## Questions for Army Corps

REPORT ON THE PERFORMANCE MONITORING SYSTEM FOR THE INTERIM WASTE  
CONTAINMENT AT THE NIAGARA FALLS STORAGE SITE  
OCTOBER 1985

#### PERFORMANCE MONITORING REPORT FOR THE NIAGARA FALLS STORAGE SITE WASTE CONTAINMENT STRUCTURE

FIGURE 2-1 LOCATIONS OF VWPTs AND PPTs ON THE WASTE CONTAINMENT STRUCTURE

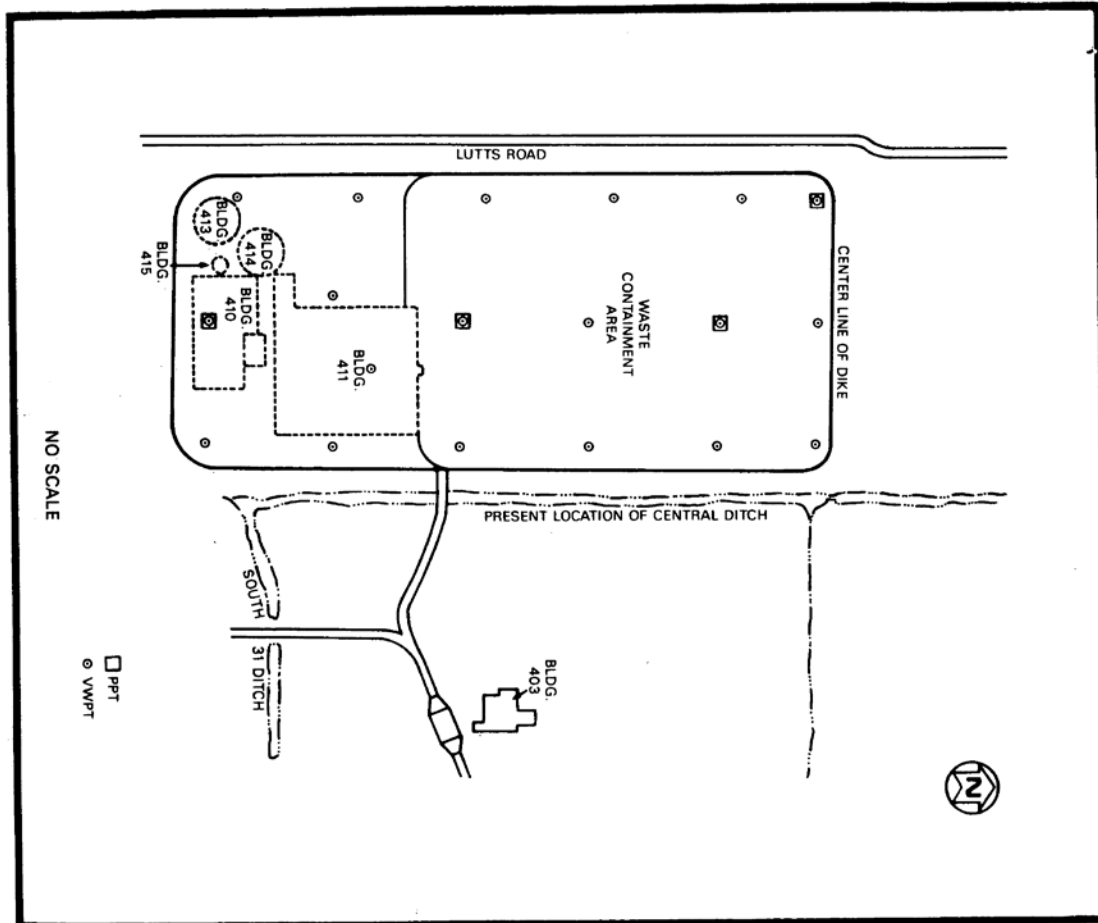
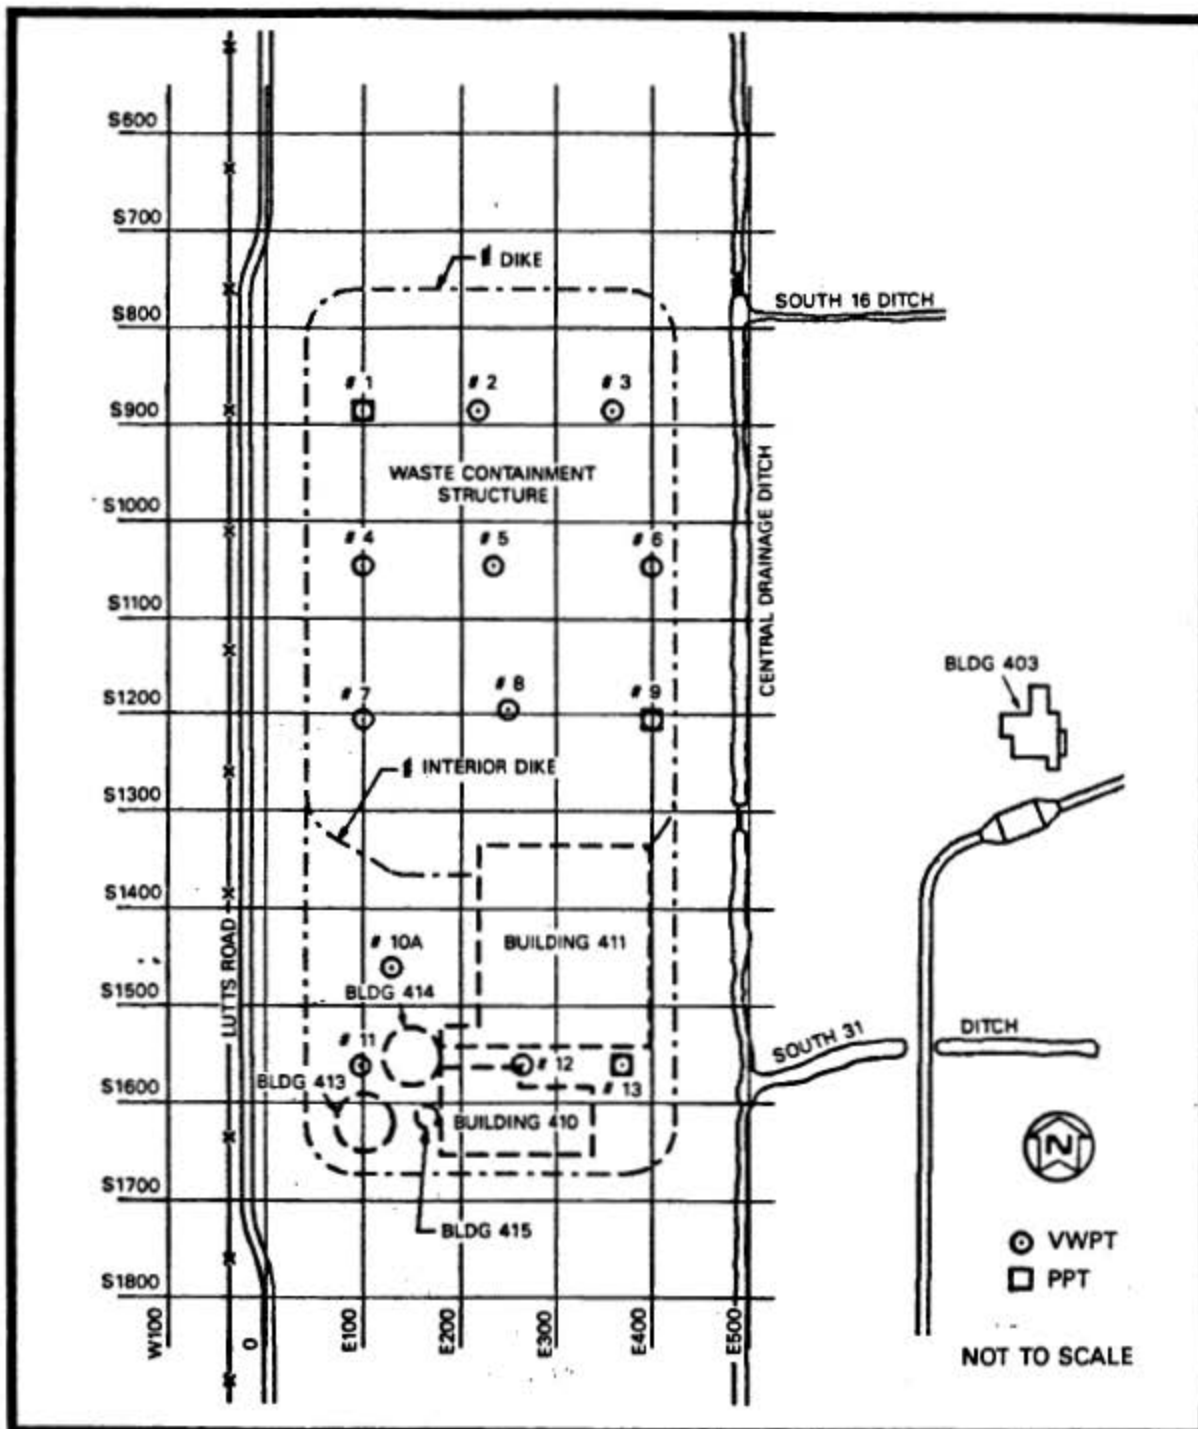
- B) There are changes in the sensor location plans between the documents item three and Item four in these notes. What is the explanation?
- C) Will the health and safety as well as drilling logs for the 14 borings into the IWCS be found and released? These documents should also be included in the "Radon Assessment Technical Memorandum" now in preparation. This is real data to validate any "potential radon" predictions.

- D) Will the USACE find and release the subsequent reports? The July 87 document states there will be a data set, at a minimum from "FY 87 -91"?
- E) Will Corps employees walk the site to the coordinates listed for the pneumatic pressure transducers (PPT) and locate the tubes for these sensors? Will the Corps perform a shallow soil excavation to uncover the wire leads from the vibrating wire pressure transducer (VWPT), sensors and test the functionality of both sets of sensors? We suggest that you do not try to locate them by mechanically excavating for them because they could get severed. These buried wires can be located with electronic metal detectors. Then they can be hand excavated safely. When they are uncovered and their location is verified. Then you mechanically excavate to do necessary tests.

- F) Sensor location 13 is near the locations where radon detection above the non detect level have been reported. Is there any indication the Sensor 13 is a source of radon venting?
